ROSA Inc.
Ramapo Organized for Sustainability and a Safe Aquifer
PO Box 712
Pomona, NY 10970

RE: Comments regarding Patrick Farm NYS DEC Application

Exhibit A

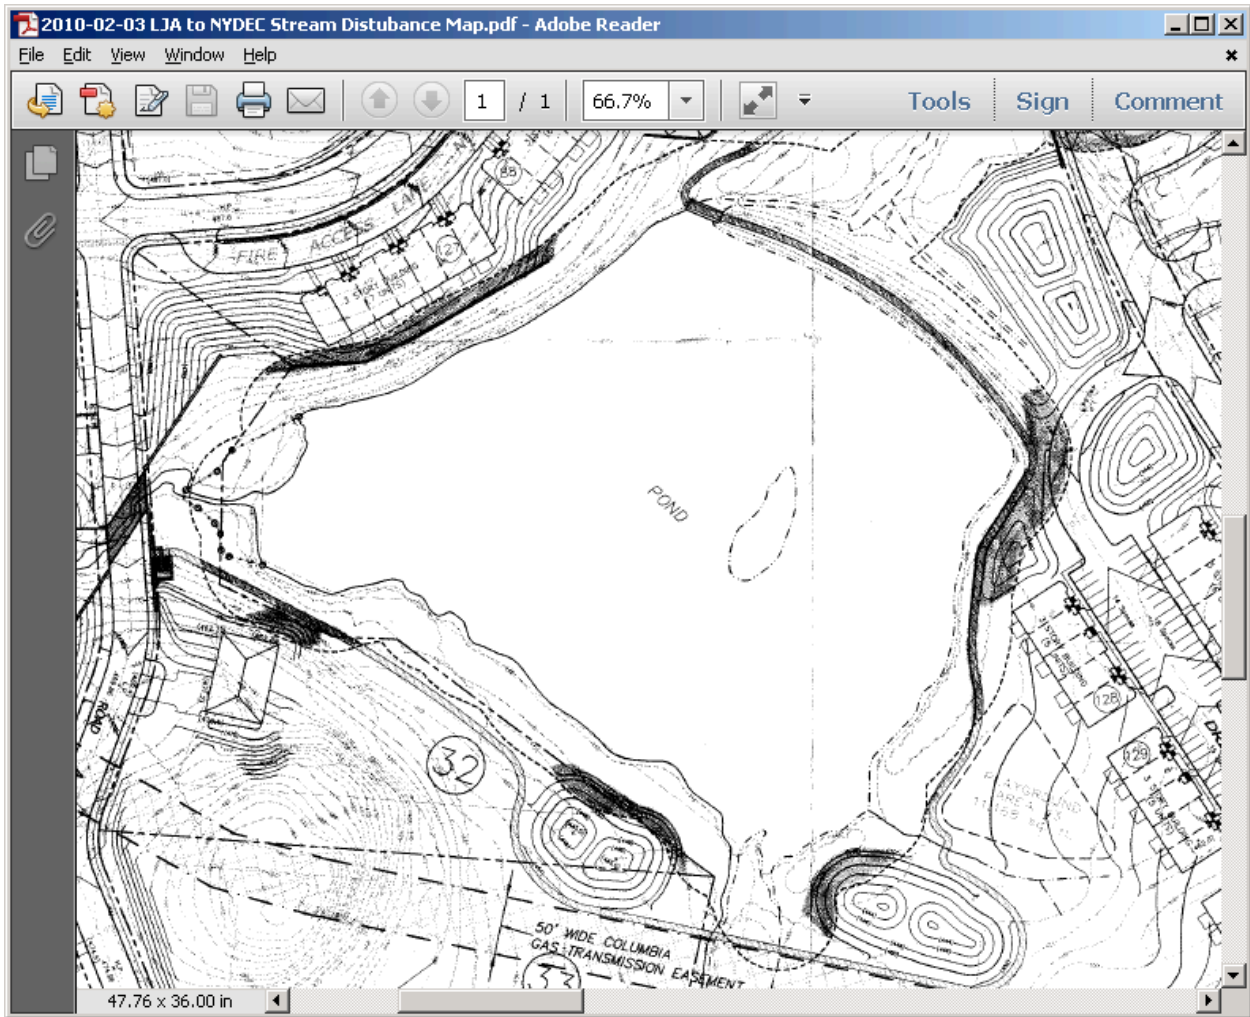
The last map of the entirety of the Project was submitted to the DEC dates 02/03/2010 and included many shaded areas indicating disturbances. Of these shaded areas only one was included in the current application and yet the project has not changed substantially.

This map was sent to the DEC, and was produced after the applicant made changes to minimize impacts pointed out by the DEC. It still shows, however, eleven areas of potential disturbances – i.e., more than the two currently shown in the application. This map also understates the number disturbances because the wetlands adjacent to the WOUS tributaries to the Pond south and north of the pond are not documented and details of the construction are not complete. Three of the stream crossings are related to WOUS that are not regulated by the DEC but three are related to DEC regulated waters.

The balances of the disturbances shown are related to the in-stream pond and the stream from the pond to the Mahwah River.

Volunteer Housing

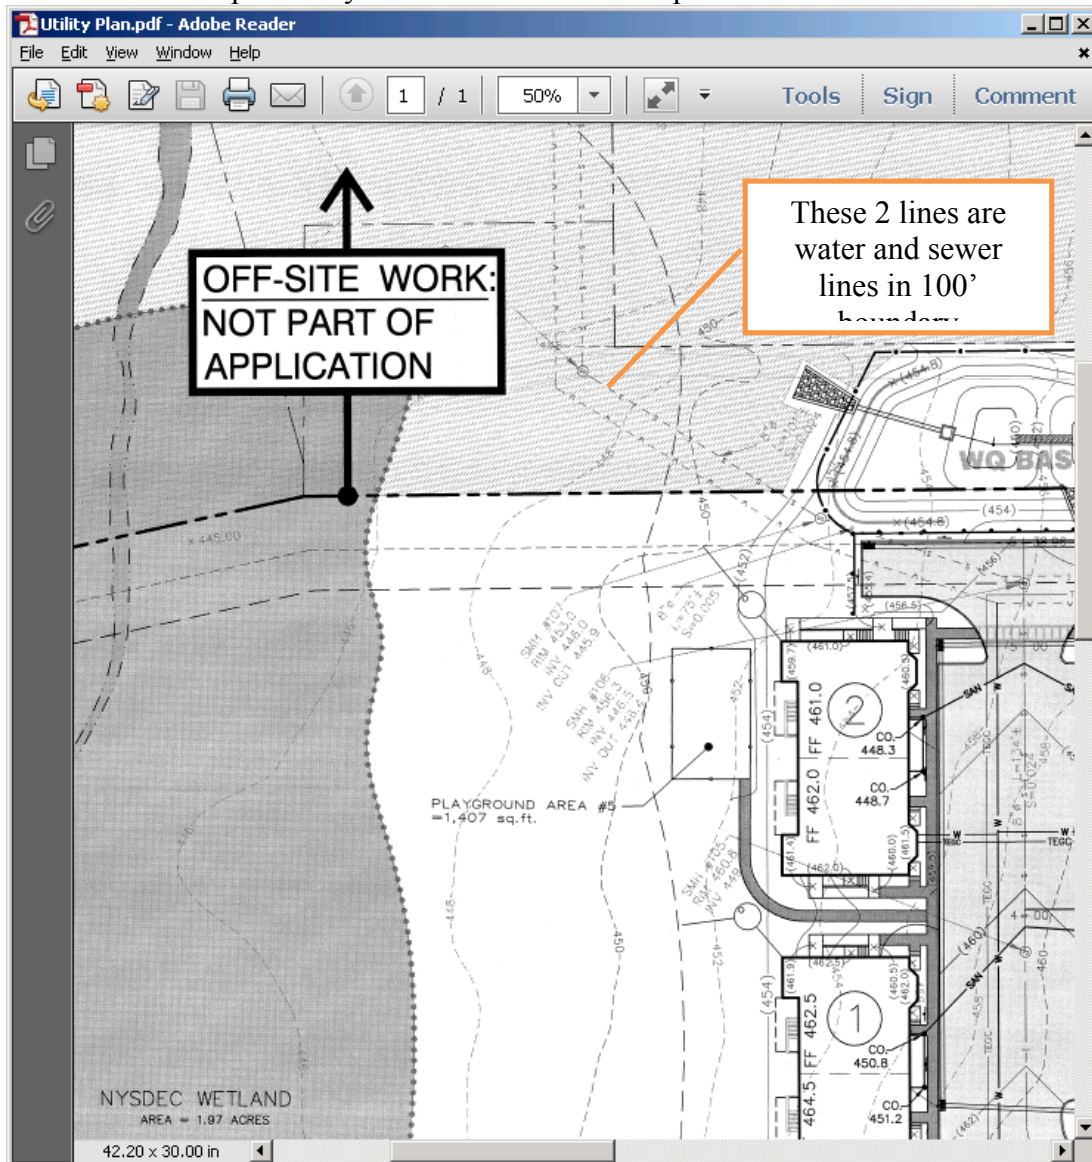
Grading and Drainage Plan – Shows water and sanitation lines within 100’ boundary behind Santi-luks property covered under Article 24. The map shows that the water and sanitation lines cross over to DEC boundary in an area of the map labeled “Off-site work, not part of application.” These lines are not reflected in other applications so even though they are in an area that is labeled “not part of application” it must be included as part of the application. Need to confirm this against the latest version of the volunteer housing plan; not 100% but it is a reasonable assumption they are still on the latest map.

Note: WQ Basin #8 is aimed at Santi-luks property – the Department should be protecting Santi-luks property against runoff from the adjoining property.

PATRICK FARM SUBDIVISION TOWN OF RAMAPO ROCKLAND COUNTY, NEW YORK	GRADING & DRAINAGE PLAN (PART 2 of 9)
	Job number: 09051
Drawn by: MAK	
Date: 05/24/10	
Scale: 1" = 40'	
Drawing Number: <div style="text-align: center; font-size: 2em; font-weight: bold;">14</div>

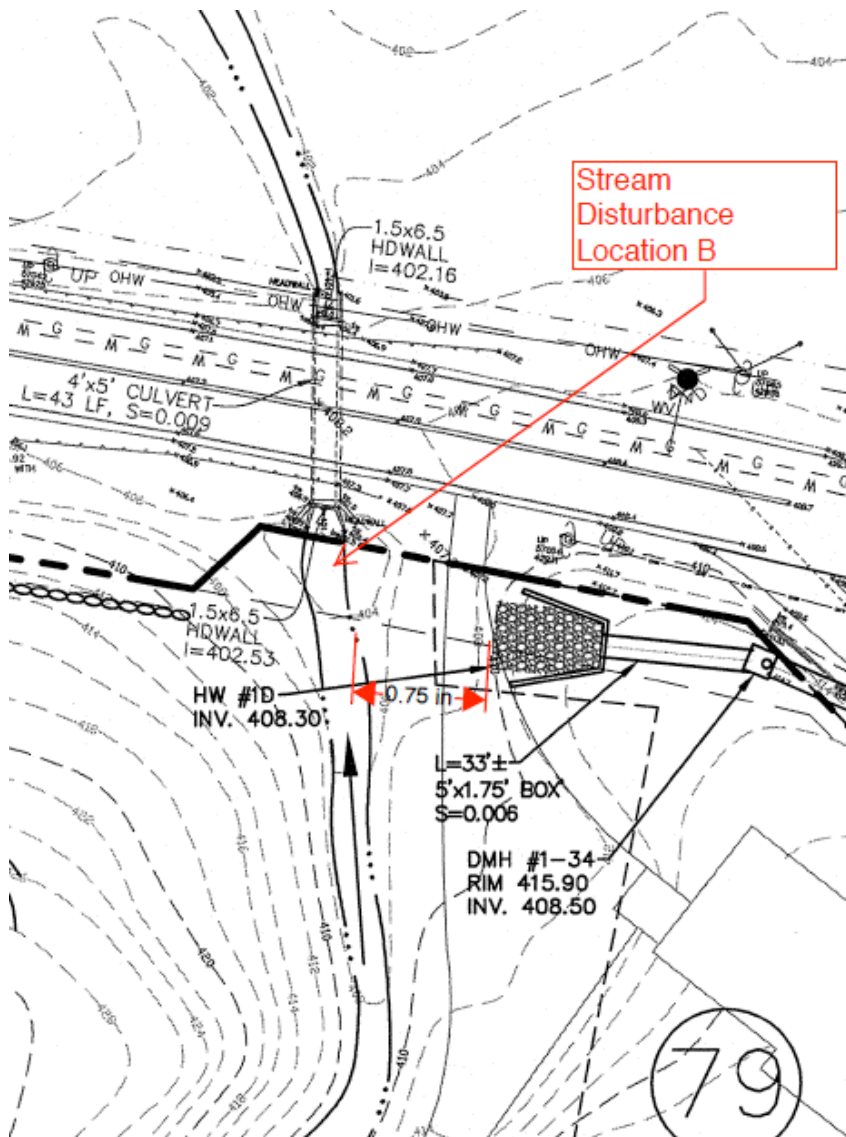
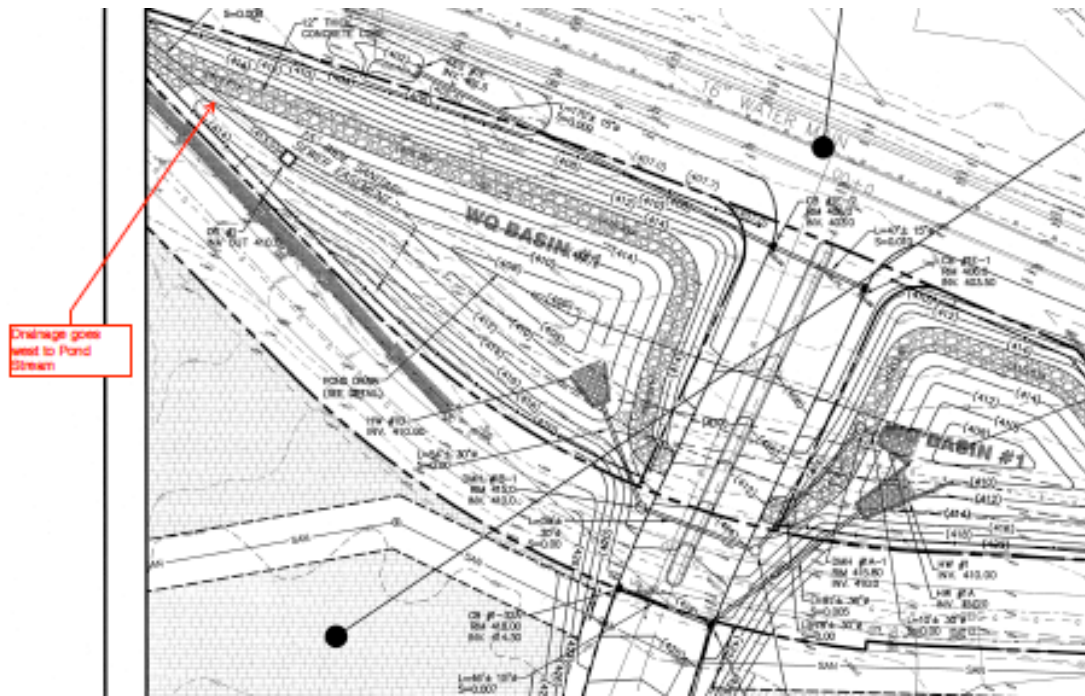
In detailed diagram of Location B in application why is the limit of the banks on north side of stream so much closer than south side? There is a drainage outflow very nearby. Are those banks confirmed?

On drawing 14 of subdivision the distance from drainage outflow from Basin #1 to stream as shown is ~30' (.75in on 1:40').

The drainage is coming from the large WQ Basin #1 which shown on drawing #15 (see next image).

Culvert #2 Road A Stream Crossing Over ACOE A

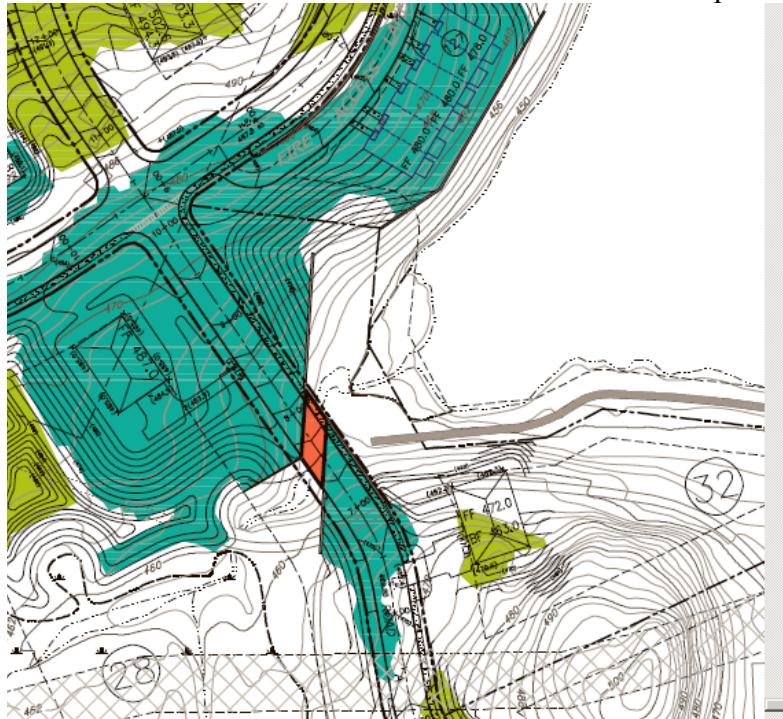
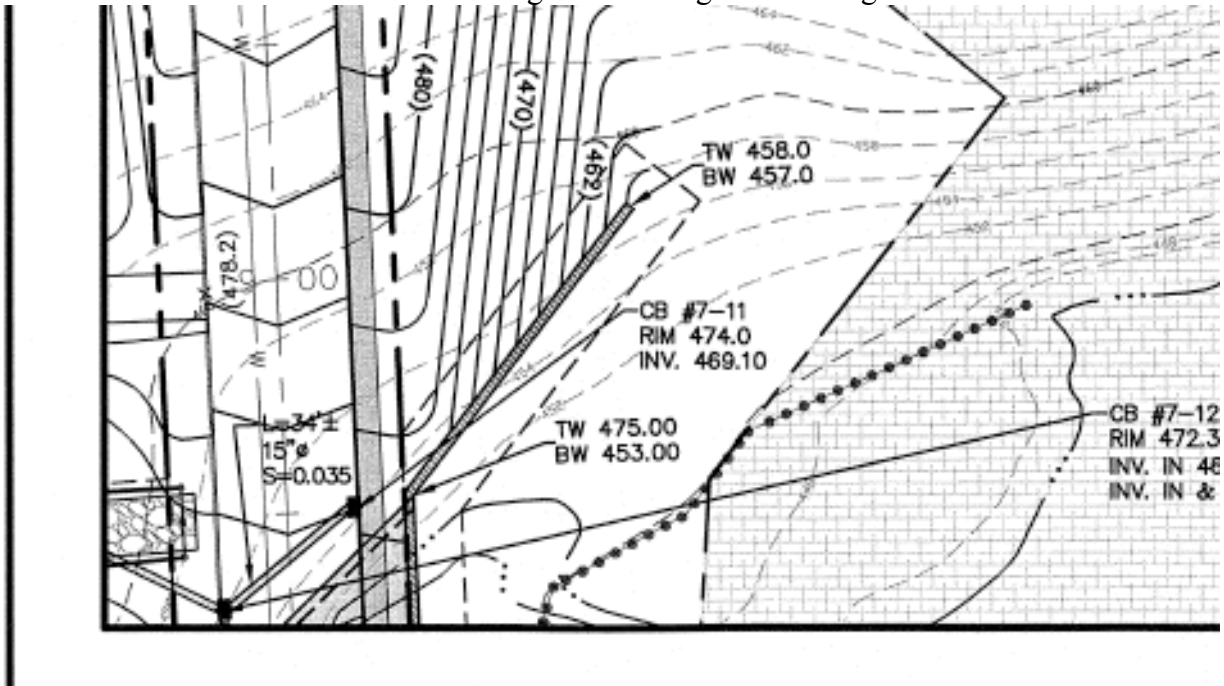
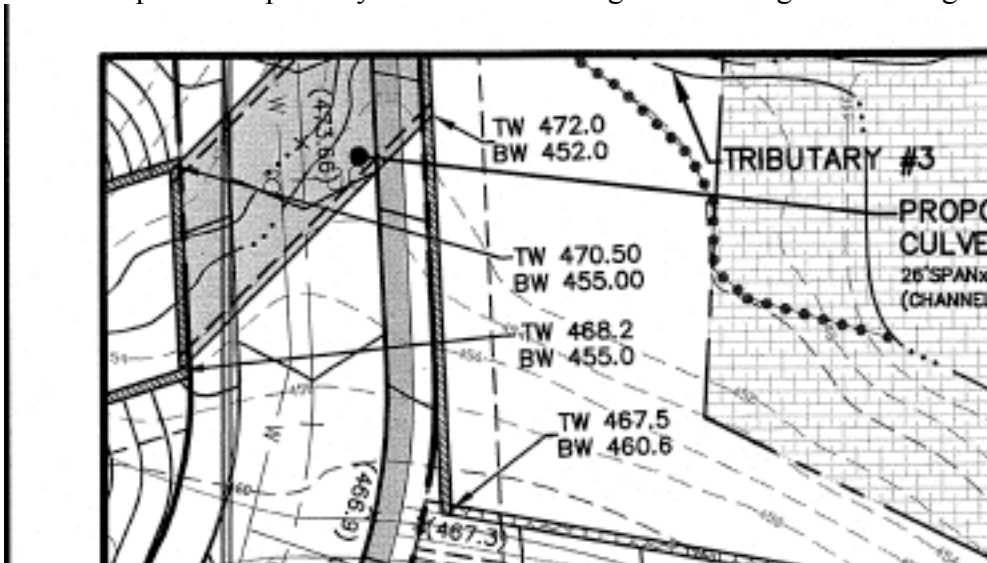
This Road is west of the pond and crosses over the stream connecting the documented ACOE Wetland A to ACOE Wetland B; however along the banks of the streams are small wetland areas that would also be considered ACOE wetlands and should be protected. On the DEIS Figure 3.1-7 below you can see a large amount of fill is planned for this area. Without an ACOE JD, the DEC cannot determine the extent of the disturbance of protected resources.

This culvert adjacent to the west corner of the pond is only partially shown without 50' boundary indicators on the Subdivision Plans Drawing #14 Grading and Drainage Part 2 of 9.

The other portion is partially shown on Drawing #18 Grading and Drainage Part 6 of 9.

Culvert #8 Road D Stream Crossing over DEC Class B Stream – Brian Brook

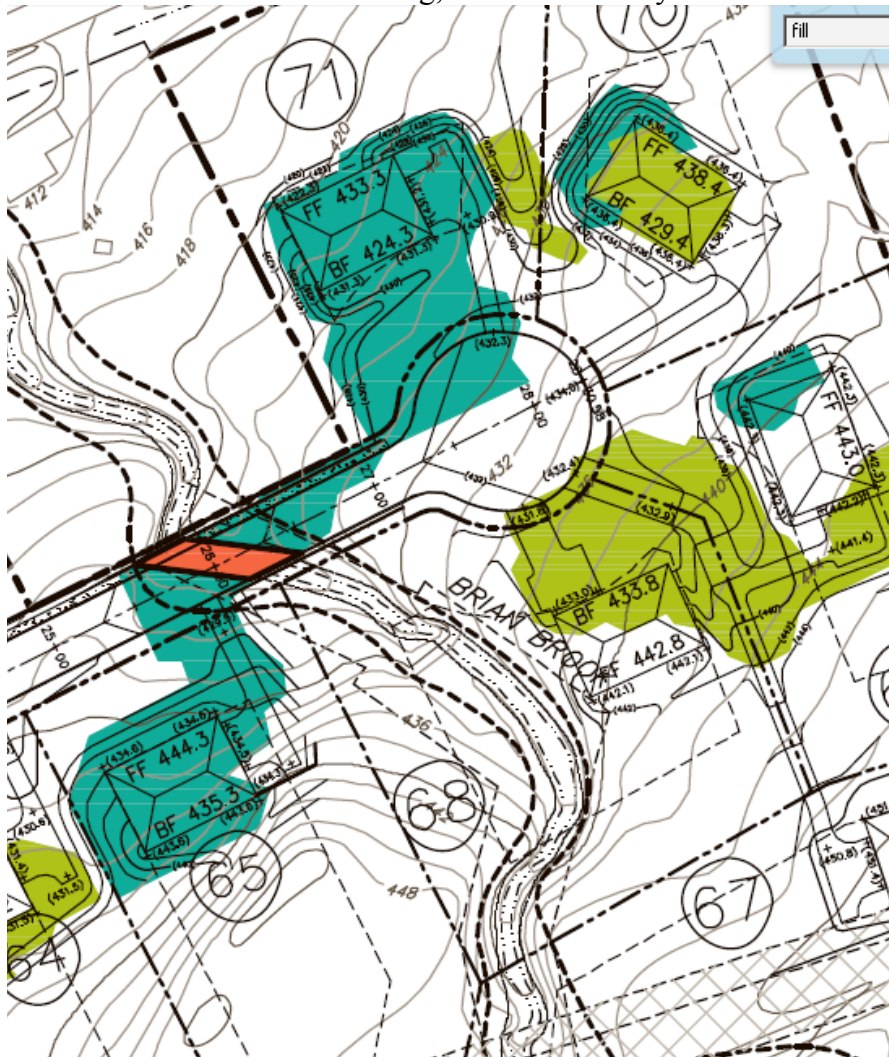
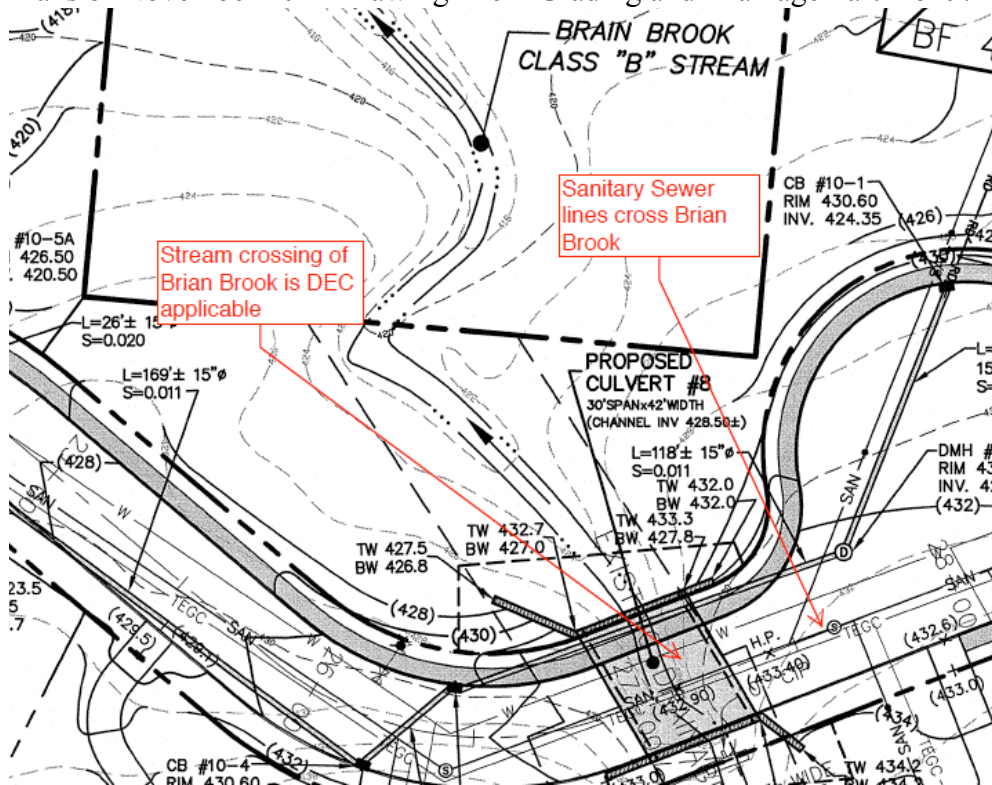
Screen Capture of cut and fill map from DEIS showing planned stream crossing of Brian Brook. Part of subdivision plan. Teal green denotes fill. Lime green denotes cuts. A statement of need should accompany all disturbances. Why do these 5 homes (67, 68, 69, 70 and 71) need to be connected to the subdivision? Why not use a common road onto Rte. 306 instead of crossing the stream?

Even if DEC agrees it is necessary, there should still be a confirmation of the beds and banks of the stream and a requirement for the developer to confirm the related cut and fill plans and the stream crossing plans. This stream crossing was not indicated in the stream disturbance application.

In addition to the stream crossing, there are sanitary sewer lines crossing the Brian Brook.

This stream crossing is still on the final subdivision plans along with sewer lines also crossing the Brian Brook and should be part of the application. This was taken from the Final Subdivision Plans of November 2011 Drawing #16 – Grading and Drainage Part 4 of 9.

Culvert #3 for WOUS tributary #3 to ACOE A

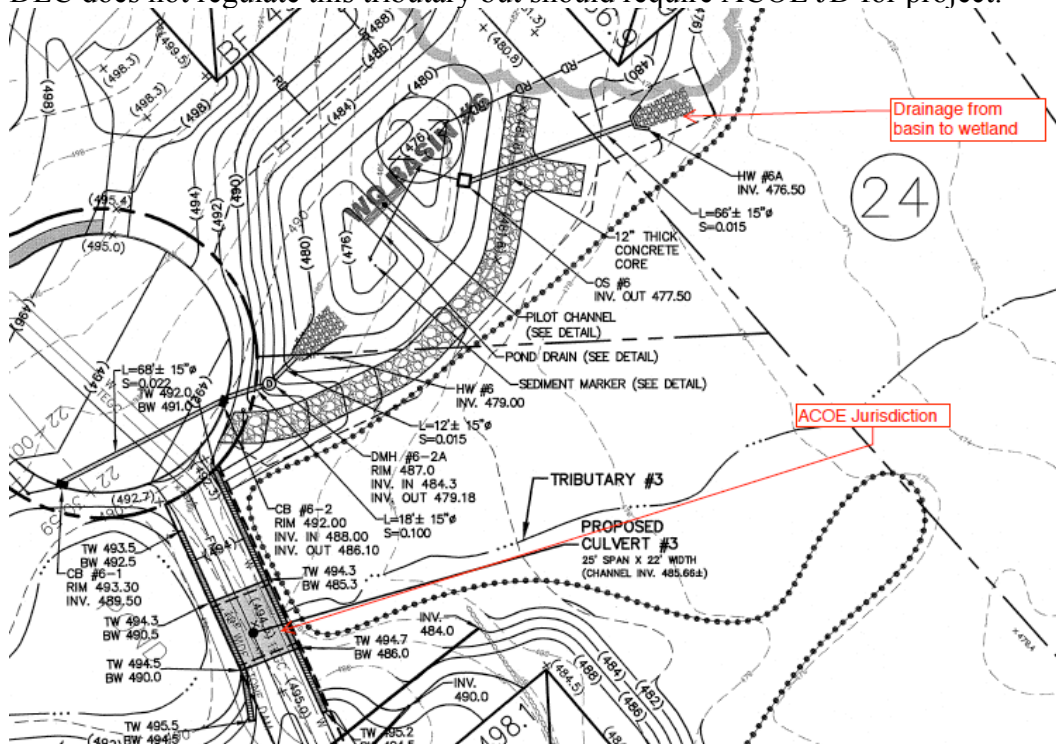
DEC does not regulate this tributary but should require ACOE JD for project.

Culvert #4 for WOUS tributary #4 to ACOE A

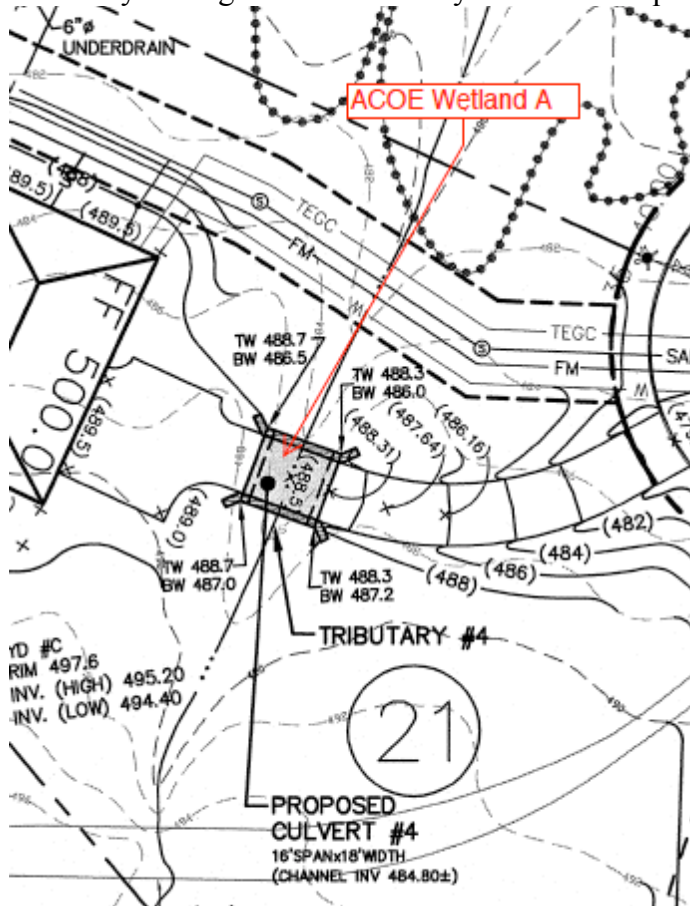
DEC may not regulate this tributary but should require ACOE JD for project.

Culvert #5 for WOUS Tributary #2 to Pond

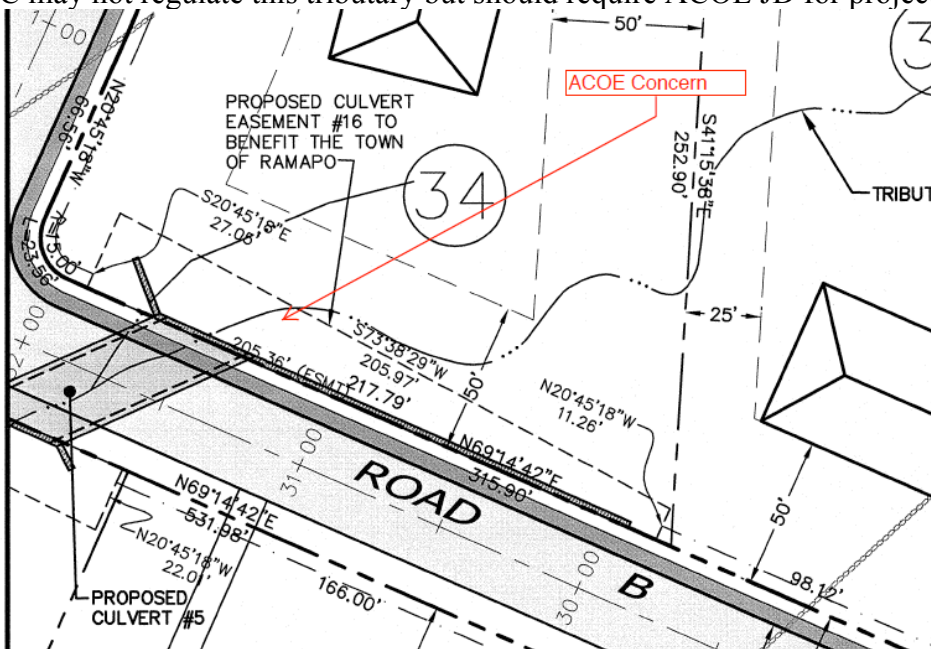
DEC may not regulate this tributary but should require ACOE JD for project.
